Date: March 29, 2022

**Project Name:** UHNBC Cardiac – Phase 1 Biomed 3rd Floor

**Project Number:** N662030002

Scale: As indicated  
Revision: 4  
Drawing No. **A700**

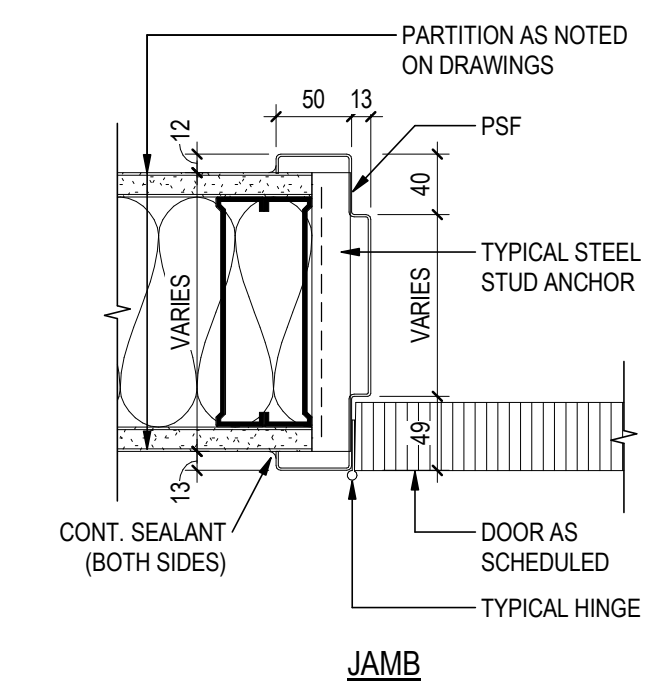
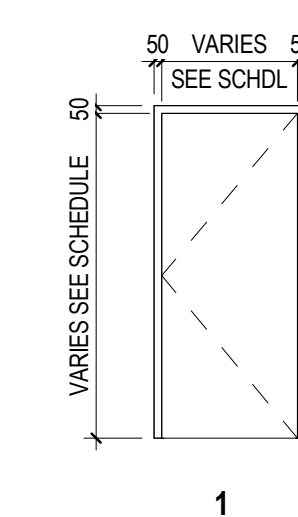
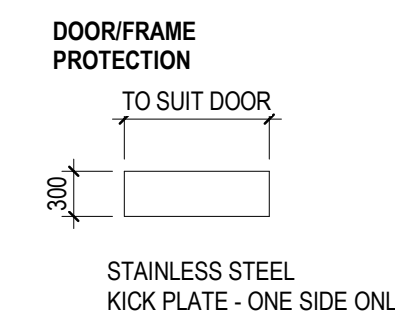
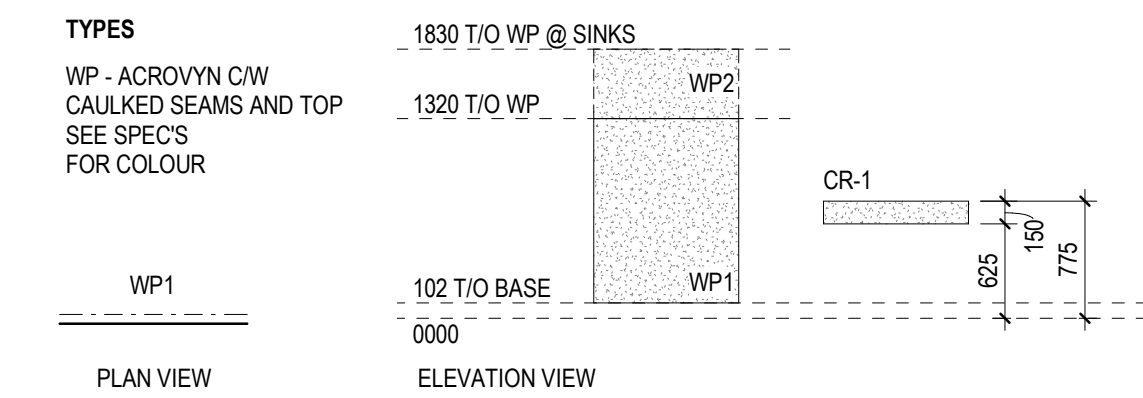
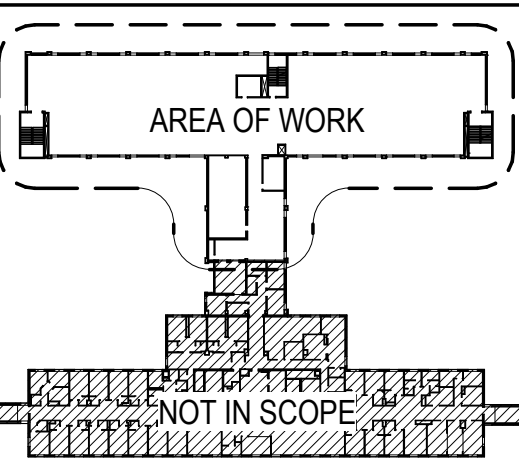
**Question:** Floor schedule on A700 does not match hatched area on drawing A900.

**Answer:** Refer to drawing A700 and A900 attached.
